Edwin I. Hatch Nuclear Plant Joseph M. Farley Nuclear Plant Vogtle Electric Generating Plant Application for Technical Specification Improvement to Eliminate Requirements to Provide Monthly Operating Reports And Occupational Radiation Exposure Reports

Enclosure 1 provides a description of the proposed change and confirmation of applicability. Enclosure 2 provides the existing TS pages marked-up to show the proposed change. Enclosure 3 provides the proposed revised TS pages. Enclosure 4 provides the List of Regulatory Commitments.

Proposed Technical Specification Changes (Mark-Ups)

5.6.4

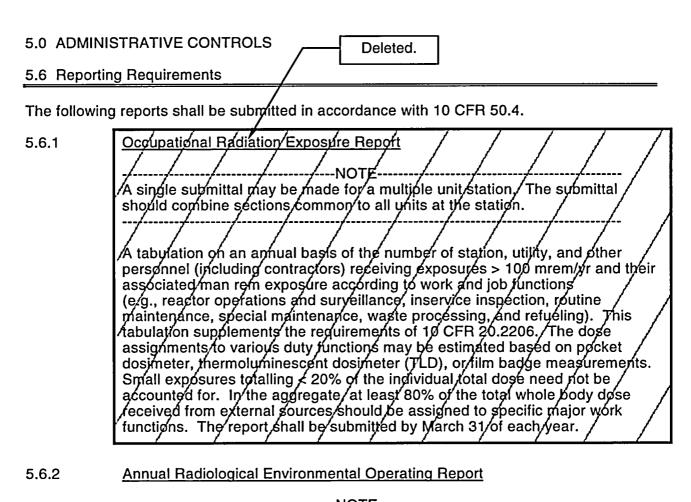
Deleted.

Monthly Operating Reports Foutine reports of operating statistics and shutdown experience, including documentation of all challenges to the pressurizer power operated relief valves or pressurizer safety valves, shall be submitted on a monthly basis no later than the 15th of each month following the calendar month covered by the report. In the event a RHR relief valve or a RCS yent is used to mitigate a RCS pressure transient, the monthly operating report shall describe the circumstances initiating the transient, the effect of the RHR relief valves or vent on the transient, and any corrective action necessary to prevent recurrence.
